Capital City Fire and Rescue (CCFR) Sectional Doors and Operators Replacement

Contract No. E10-219

ADDENDUM NO.: THREE

DATE ADDENDUM ISSUED: April 21, 2010

AUXILIARY TROLLEY MODIFICATION

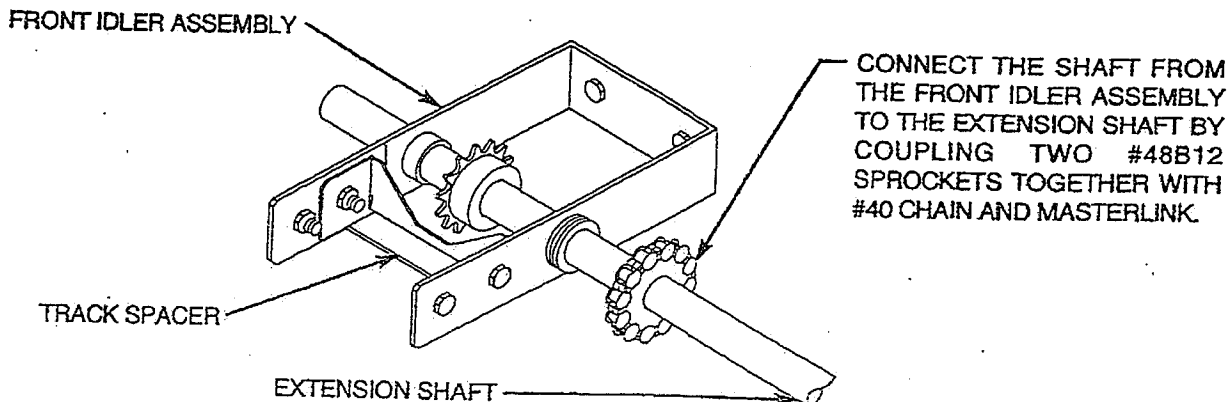
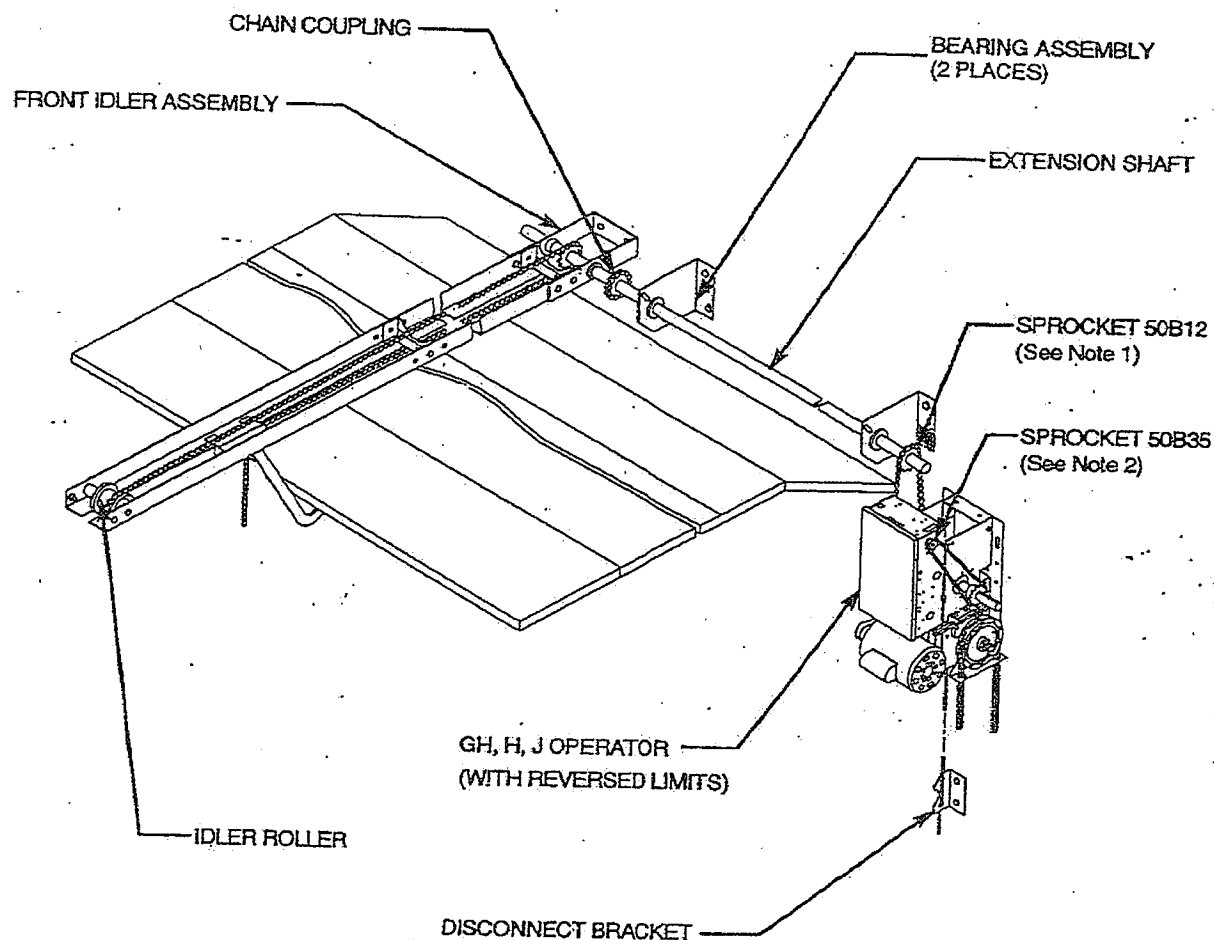
ADD: Provide and install twelve (12) Auxiliary Trolley Modification assemblies to provide drawbar-type operation as applicable to conversion to jackshaft type operators at this station only.

Basis of design: Chamberlain LiftMaster Professional –Auxiliary Trolley Modification or approved equal. See manufacturer's cutsheet, attached.

HAGEVIG FIRE TRAINING CENTER

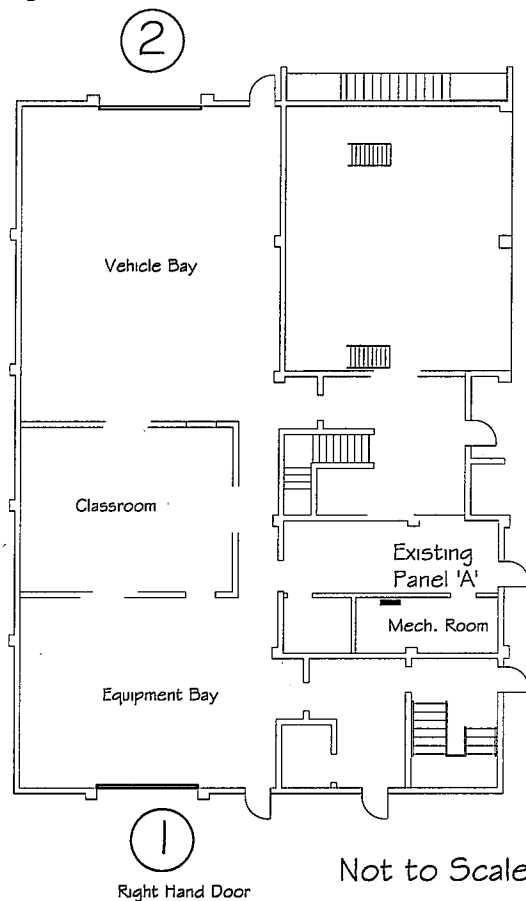
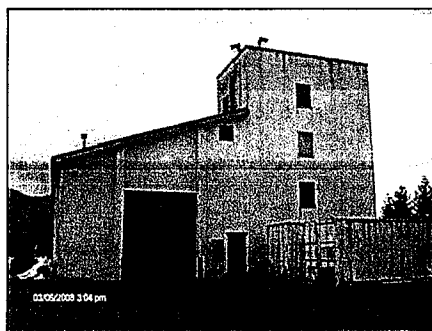
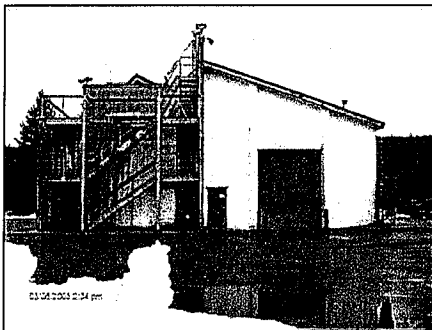
ADD: Hagevig Fire Training Center- Plan drawing, attached to this Addendum.

Furnish and install the following at two (2), existing
14'-0" high x 12'-0" wide rolling cannister-type doors:

Two (2) H-50-11 LiftMaster brand (or approved equal) operators for rolling steel doors, 110 Volt, single phase with chain hoist option and steel hood mounted brackets. Install weather-proof (NEMA-4) 3-button switches and pneumatic sensing-edge device option at bottom edge of both existing doors. Electrical work includes conduit installation and relocation as required, installation of two new 25 Ampere, single pole breakers and wiring to existing electrical Panel 'A'.
